**TO:** Brian Wilson, CVL Consultants of Colorado, Inc.

**FROM:** Stacey Nerger, Associate Planner

**SUBJECT:** Trails at Crowfoot Filing No. 9 – Final Plat  
[Application SUB17-040]

**TRAILS AT CROWFOOT FILING NO. 10**

# TRAILS AT CROWFOOT FINAL LANDSCAPE PLANS

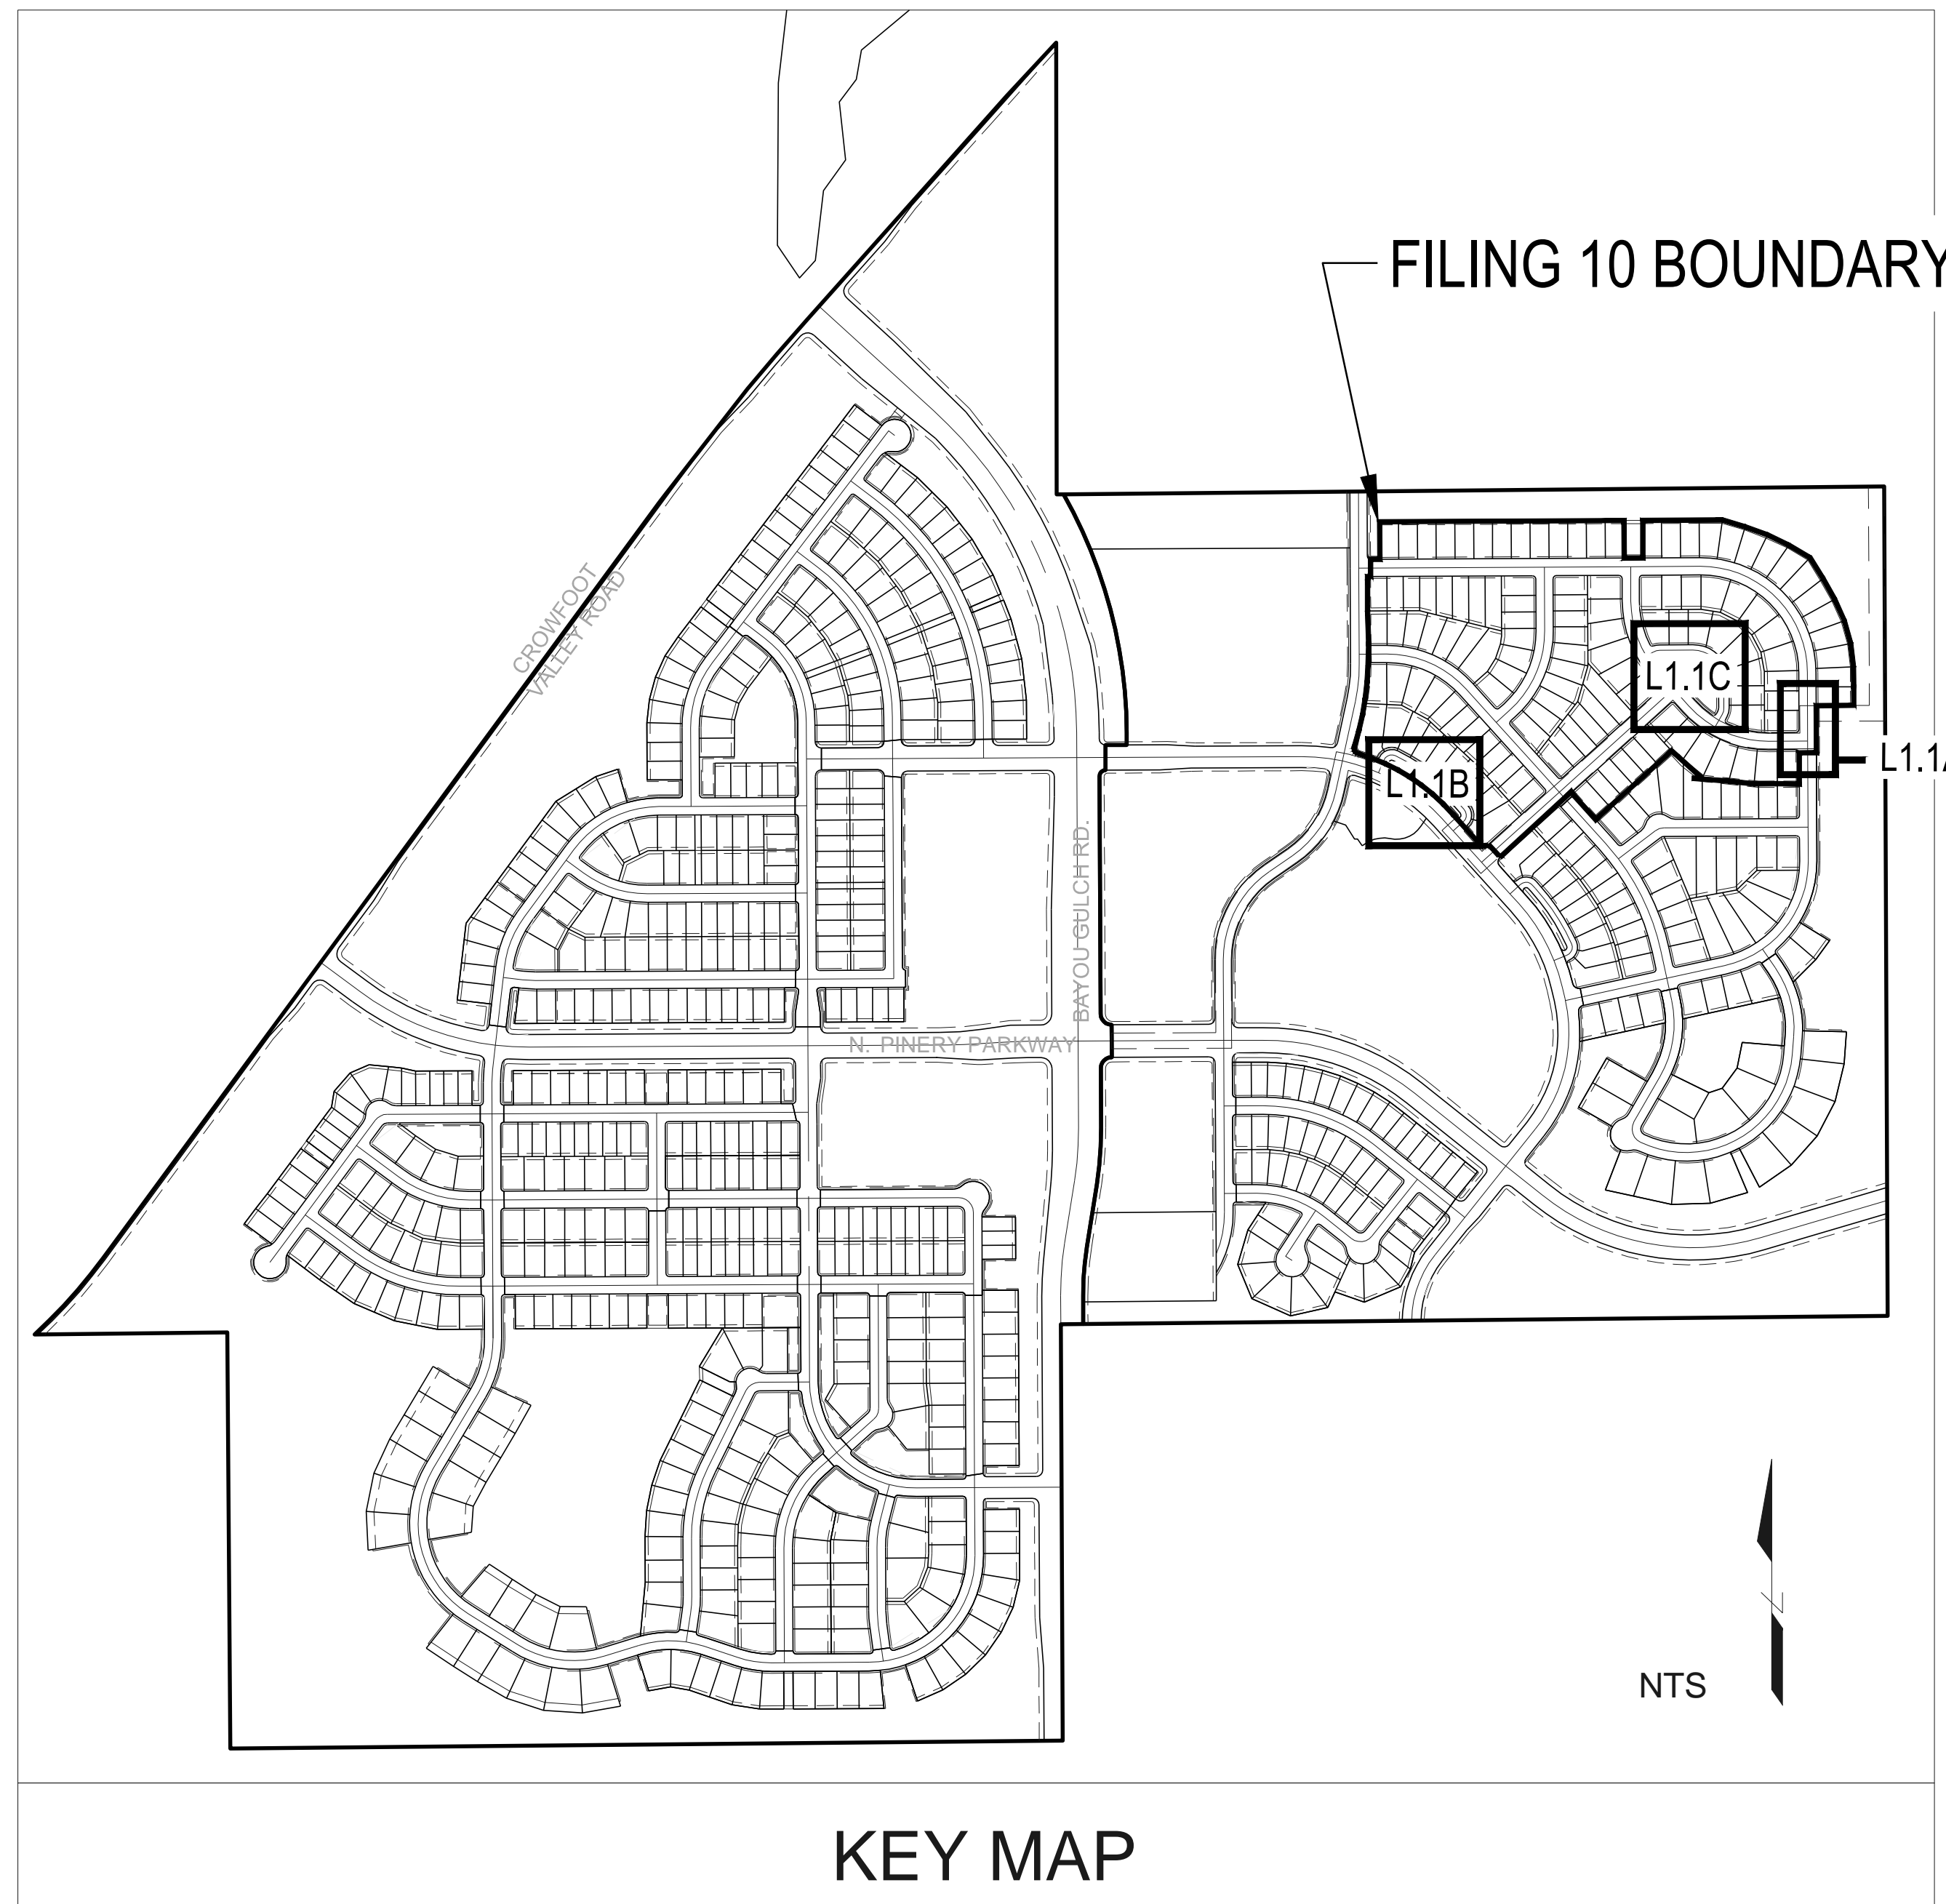
**\*\*All landscaping including streetscape and tract landscaping will need to be shown on the final landscape plans. This landscaping will also need to be included within the cost estimates that will be included within the Subdivision Agreement.**

Sheet Name  
LANDSCAPE COVER SHEET

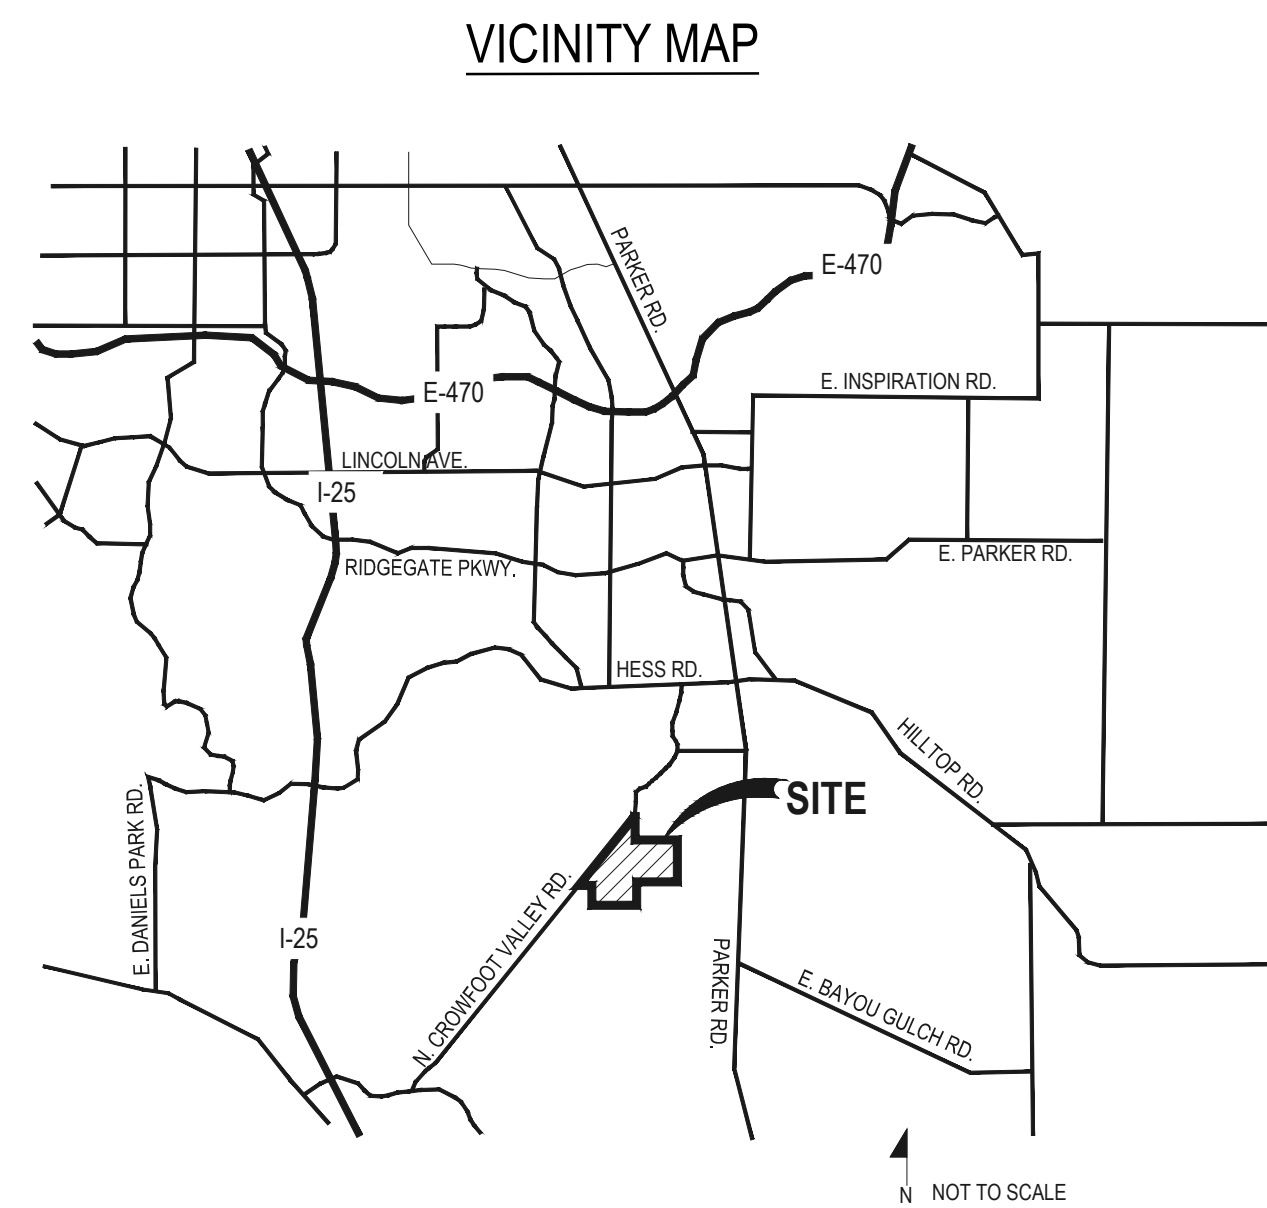
Please remove the signature blocks for public works. Landscape plans will be reviewed and stamped approved by Planning.
